IEEE Std 488.1™-2003
(Revision of
IEEE Std 488.1-1987)

Errata to IEEE Standard for Higher Performance Protocol for the Standard Digital Interface for Programmable Instrumentation

Correction Sheet
Issued 6 July 2015

Figure 5—AH state diagram

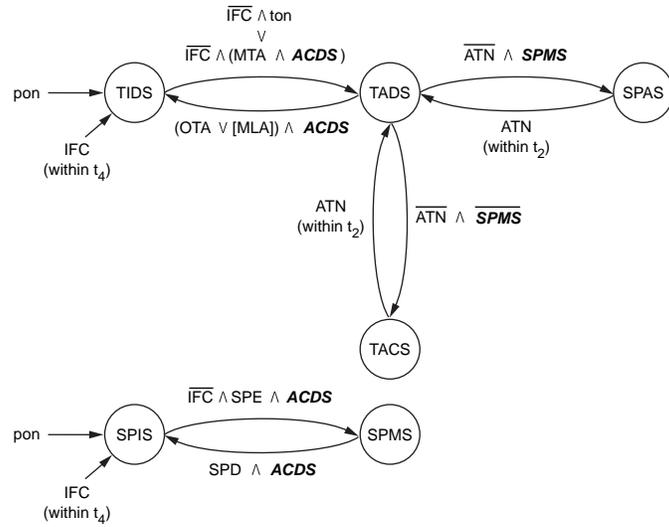
Page 24, **Figure 5—AH state diagram** is incorrect; it should be replaced with the following:
